HISTORIC AND DESIGN REVIEW COMMISSION

Agenda Item No: 19

HDRC CASE NO: 2015-462
ADDRESS: 236 E ROSEWOOD AVE
LEGAL DESCRIPTION: NCB 6728 BLK 4 LOT 18 19 AND 20
ZONING: MF33 H
CITY COUNCIL DIST.: 1
DISTRICT: Monte Vista Historic District
APPLICANT: Trent Patrick/Patrick Remodeling
OWNER: Dr. Frank Duperier
TYPE OF WORK: Demolition of Existing Accessory Structure and New Construction
REQUEST:

1. Demolish the rear accessory structure at 236 E Rosewood;
2. Construct a new garage in place of the existing accessory structure. The new construction will closely match that of the existing accessory structure.

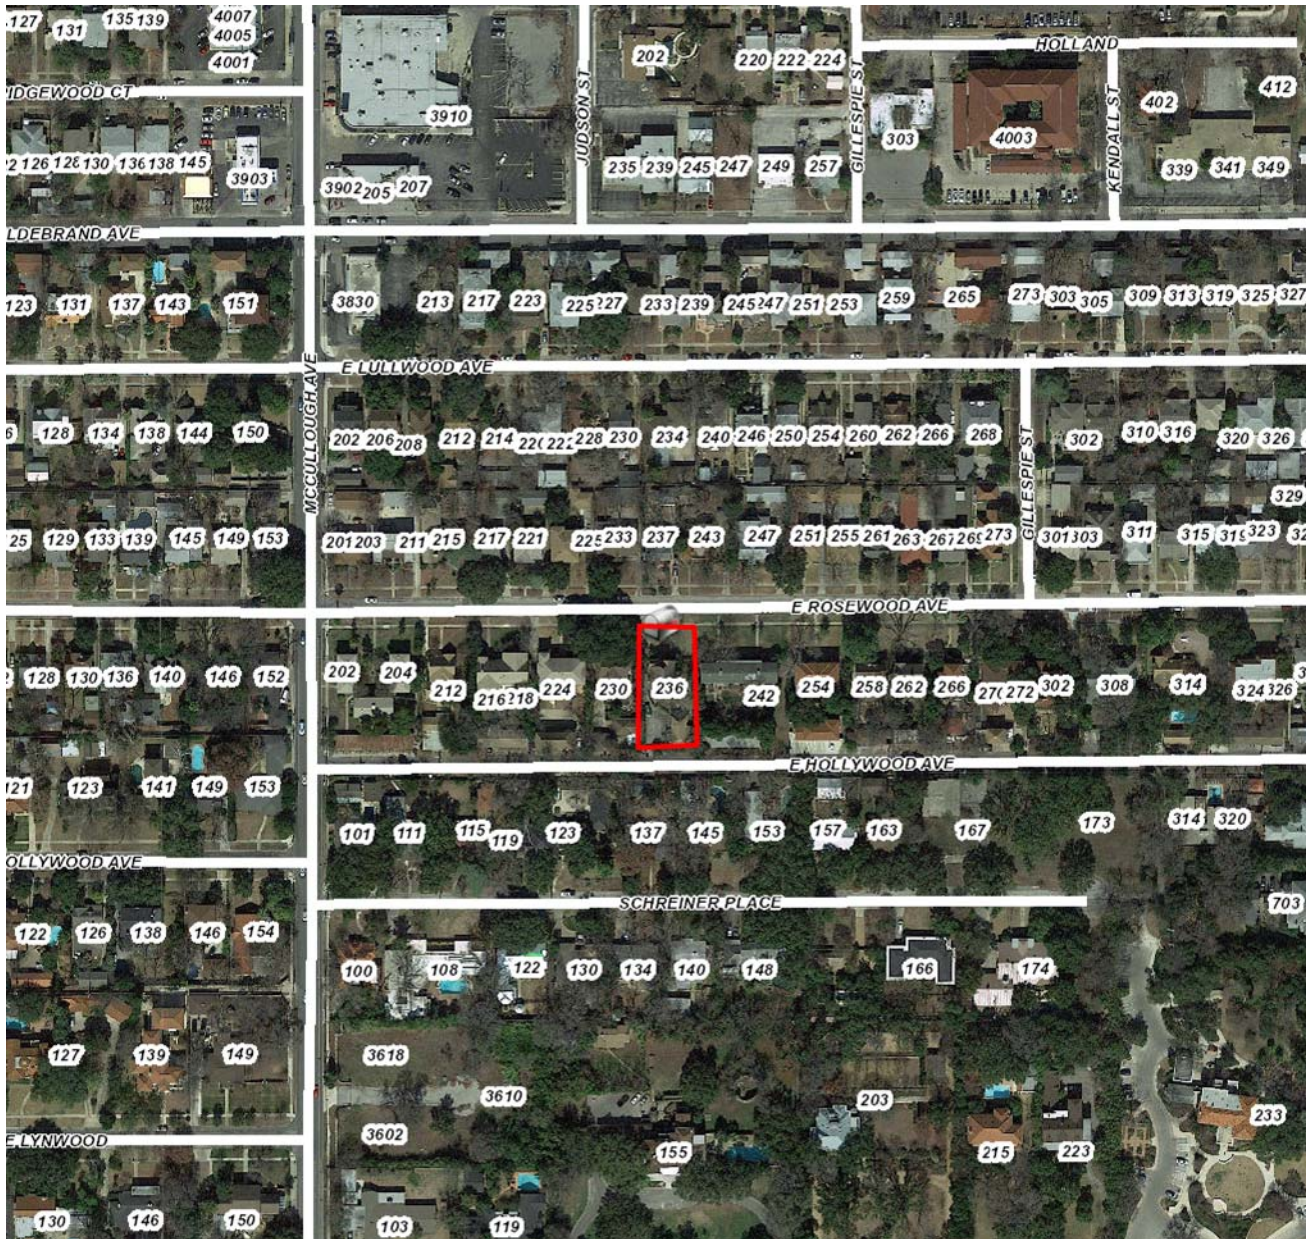
- a. The home at 236 E. Rosewood and its accessory garage first appear on the 1924-1952 Sanborn map. The existing garage mirrors the footprint of accessory illustrated on the Sanborn map.

236 East Rosewood
S.A., TX 78212

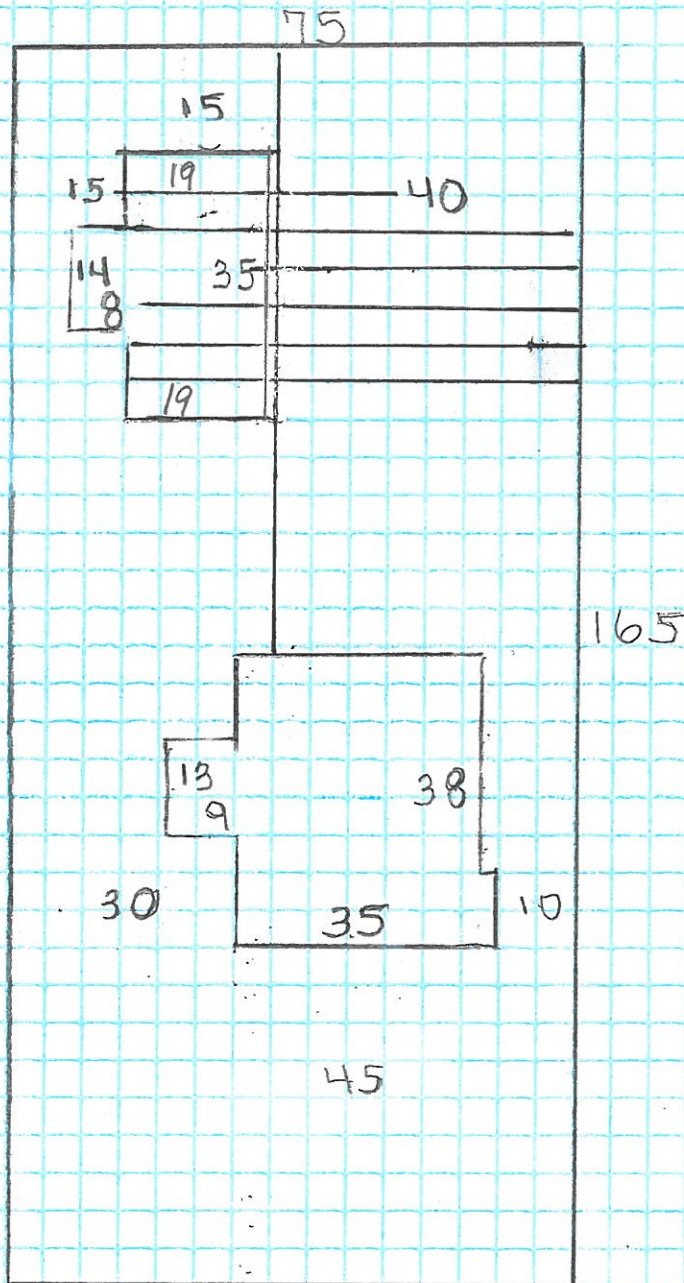
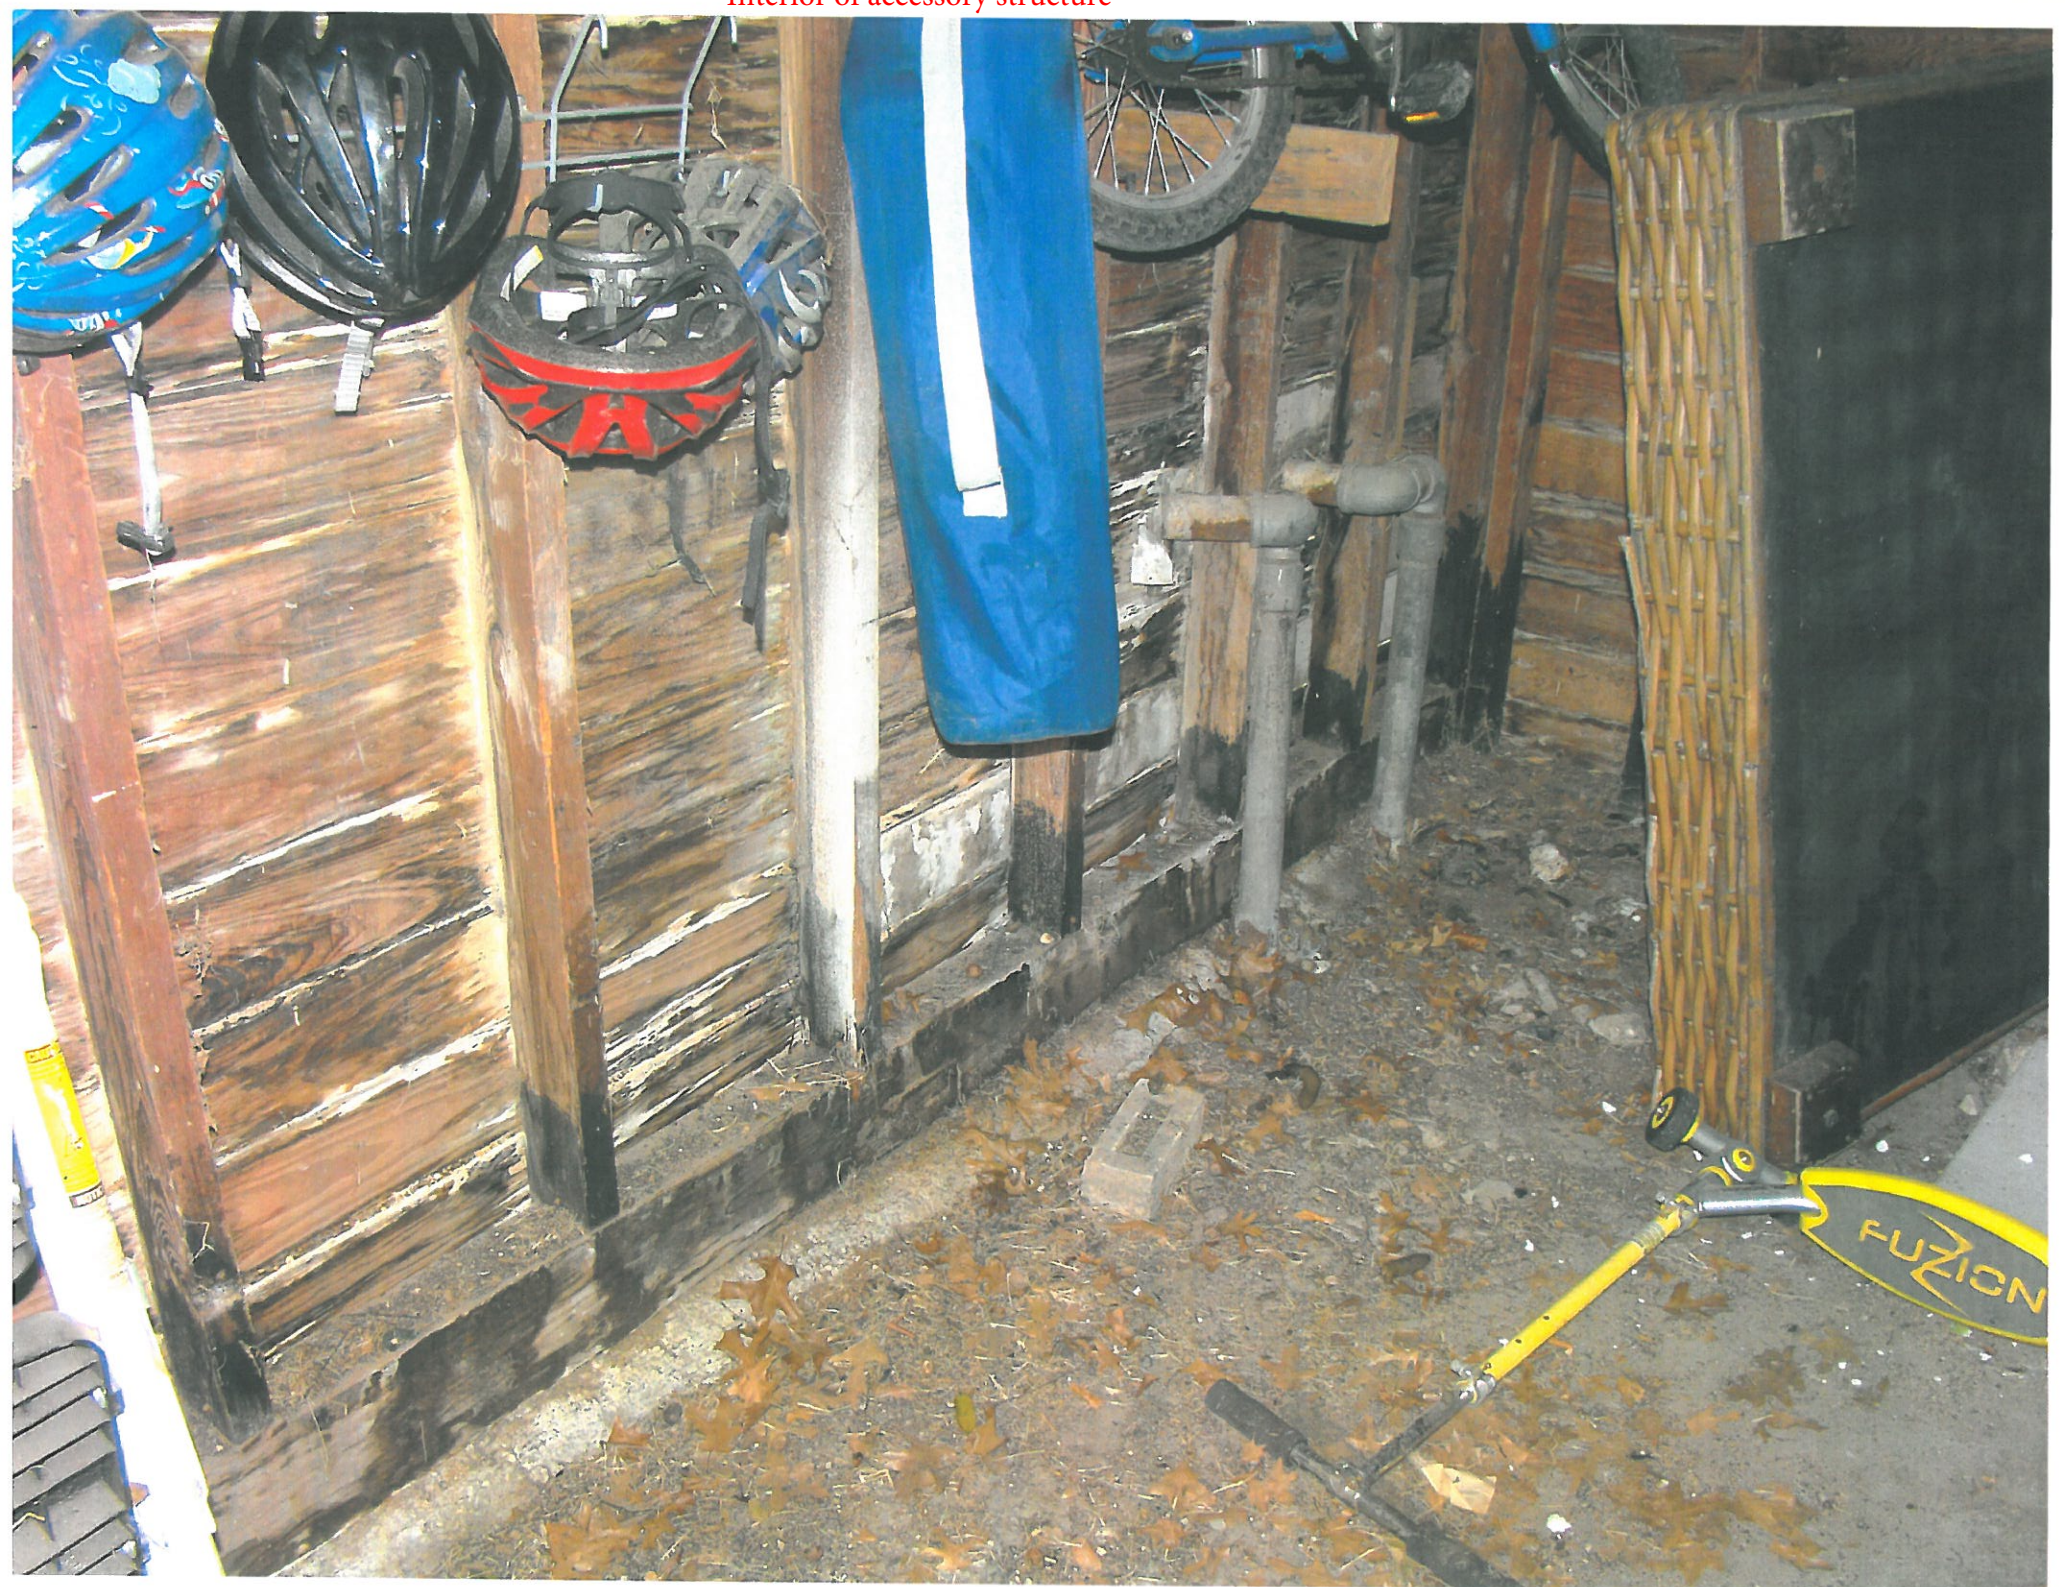
- b. The accessory structure features sliding garage doors made of wood and glass that appear to be original to the structure, true 2-inch drop siding, evidence of a wood shingle roof that has since been replaced with asphalt shingles and a gable-on-hip roof. Consistent with the Guidelines for Maintenance and Alterations Principle #2, maintaining and repairing features is preferred over replacing features as to maintain the high quality materials, character, and embodied energy of historic buildings. However, if features are deteriorated beyond repair (more than 50%), in kind replacement using new components that match the original as close as possible should be considered. Pictures submitted by the applicant show that the majority of its original material is in good condition and not damaged beyond repair.

- rooftop unique

- condition is good

- doors appear original - sliding

- true 2" siding

garage is contributing

ELEVATIONS

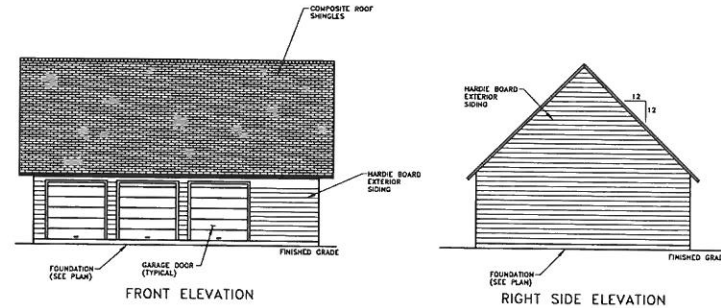
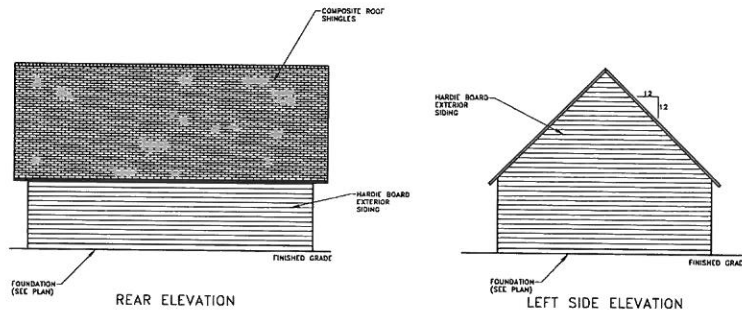
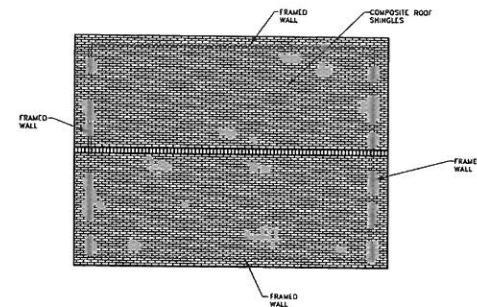
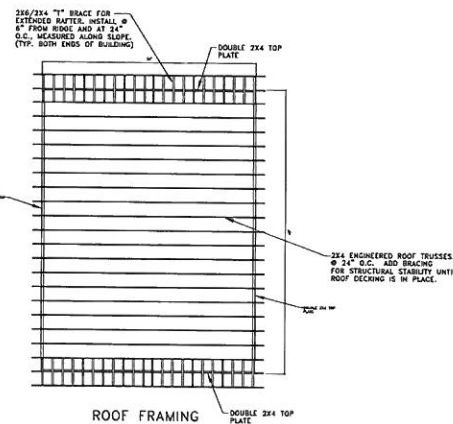
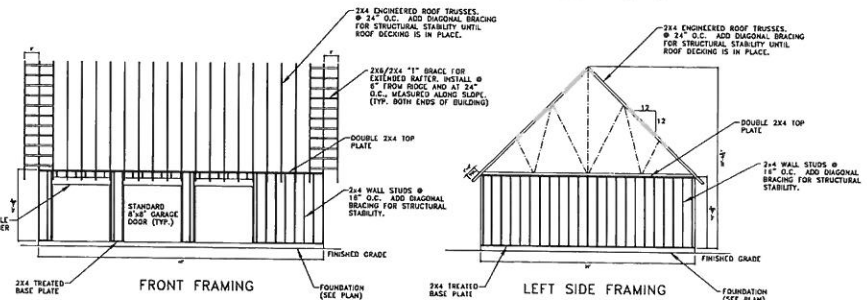
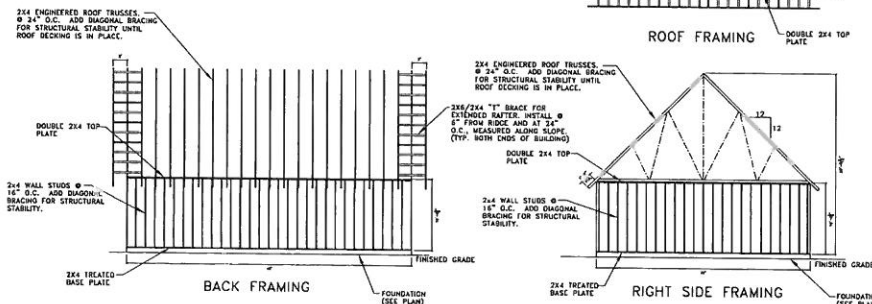
- g. The proposed new garage will feature a similar footprint and rear orientation as the existing accessory structure. This is consistent with the Guidelines for New Construction, 5, B, i., which recommends new garages match the predominant garage orientation found along the block.

- h. According to the Guidelines for New Construction, 4, A, i., new construction should not attempt to mirror or replicate historic features, but should not be so dissimilar as to distract from or diminish the historic interpretation of the district. The proposed roof style of the new garage will feature side gables, and will not feature the hip-on-gable style seen on the existing accessory structure. This is appropriate and consistent with the guidelines.

- i. The proposed garage will feature Hardie Board siding and a composite shingle roof. According to the Guidelines for New Construction, 3, A, iii and v., Hardie Board or other fiberboard siding, may be appropriate for new construction in some locations as long as new materials are visually similar to the traditional material in dimension, finish, and texture; and roof materials should be similar in terms of form, color, and texture to traditionally used in the district. Staff finds these proposed materials to be consistent with the guidelines, and recommends that the Hardie Board siding be visually similar to the existing wood siding found on the existing accessory structure.

- j. The proposed garage will feature contemporary overhead garage doors. According to the Guidelines for New Construction, 5, A, v., garage doors with similar proportions and materials as those traditionally found in the district should be incorporated into new designs. Contemporary overhead doors would not be consistent with the guidelines.

1. Staff does not recommend approval for item 1 based on findings a through e.
2. If demolition is approved, then staff recommends conceptual approval of the proposed replacement plans based on findings f – j.
